PLACE DIRECTORATE  
Highway Development Control

My Ref: HDC/2021/1089 & 1090

Date: 28/10/2021

**Subject:** Hybrid application for employment development comprising:- a) Full planning permission for: earthworks to create development platforms; strategic drainage ponds and associated drainage infrastructure; and location of strategic landscaping and ecological areas. b) Outline planning permission seeking approval over means of access and landscaping for employment use development (use classes E/B2/B8) and associated infrastructure works.

Figure Number:  
 Figure 41

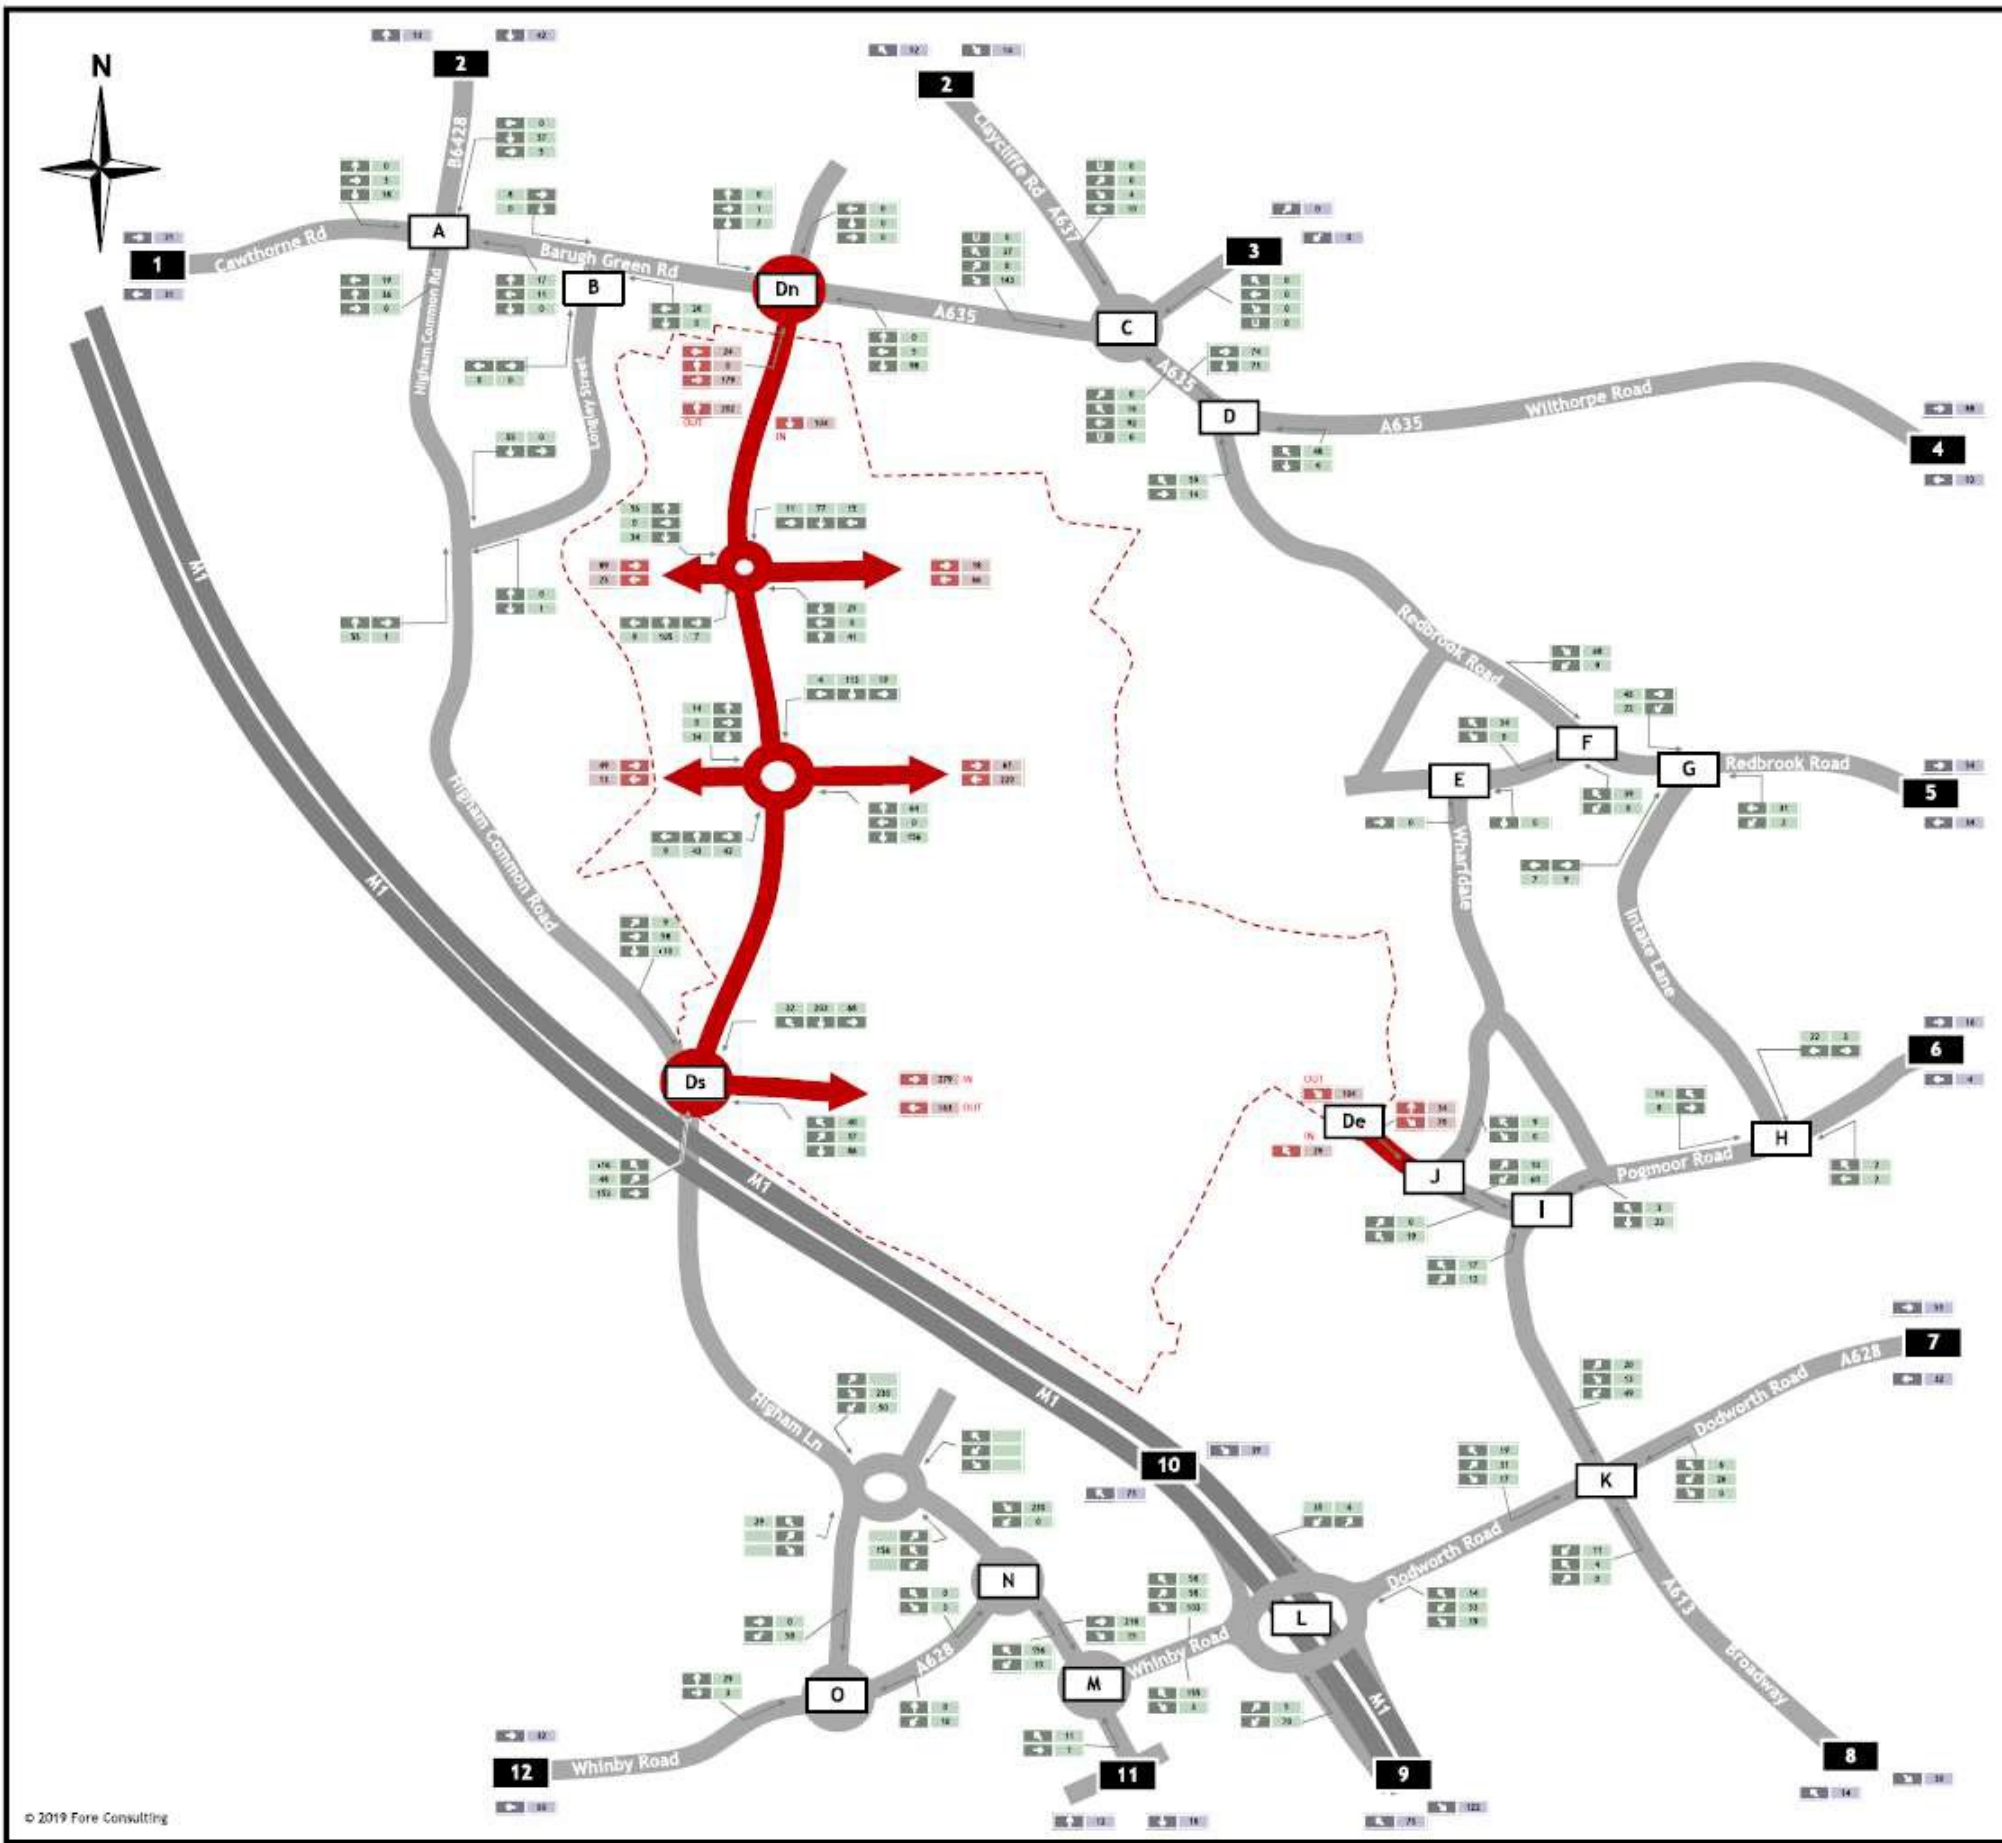
Appended below is an extract from the TA appendices showing the network flow diagrams for all development generated vehicles trips in the AM and PM peak hours. Figures 41 & 42 are shown in Passenger Car Unit (PCU values), where all vehicle types are factored together under a standard approach to provide a single uniform total traffic generation figure. It is noted that the TA also presents a breakdown of trips by HGV, the principle of which is welcomed for understanding the breakdown of predicted impact.

The local highway network is represented in Figures below with the predicted development vehicle movements shown for each junction in green cells and for each entry point to the network in blue cells. It is noted that of the 11 entry points to the network a total of eight (72%) in the AM peak and nine (82%) in the PM peak show values of vehicle movements in excessive of a 30 two trip threshold, indeed some are substantially above. No rationale is provided in the TA to support the lack of wider network assessment and the assessment should be updated to include an impact assessment of all junction locations where a >30 two-way vehicle movement impact is predicted.

The above requirement does not include the need to assess the development impact of the current under construction works to Pogmoor crossroads (Junction K on the appended figures) but does include any locations east and south of the current extent of those works.
